# **API Standards 620, 650, and 653 Interpretations— Tank Construction and In-Service Inspection**

**Answers to Technical Inquiries**

API PUBLICATION 850  
FIRST EDITION, NOVEMBER 1997

## Standard 650, Ninth Edition—Section 3.5

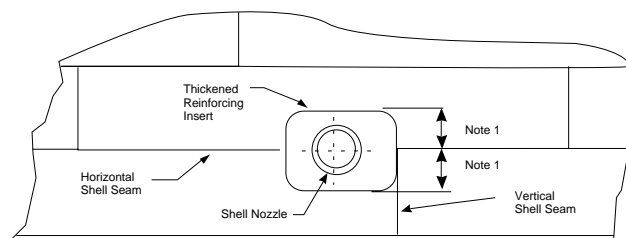
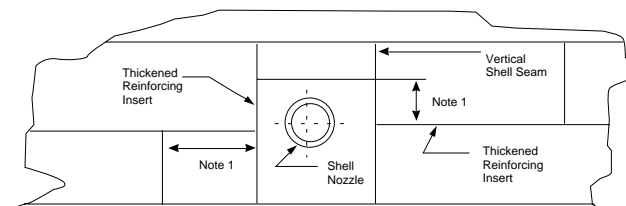
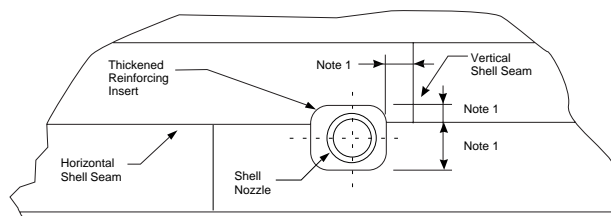
**Reply:** The requirement to provide an annular plate depends upon the material group and stress levels in the bottom shell course. Refer to paragraph 3.5.1. The question cannot be answered without more information being provided. Bottom plate thickness, the NDE applied, and the material toughness are not factors in the decision.
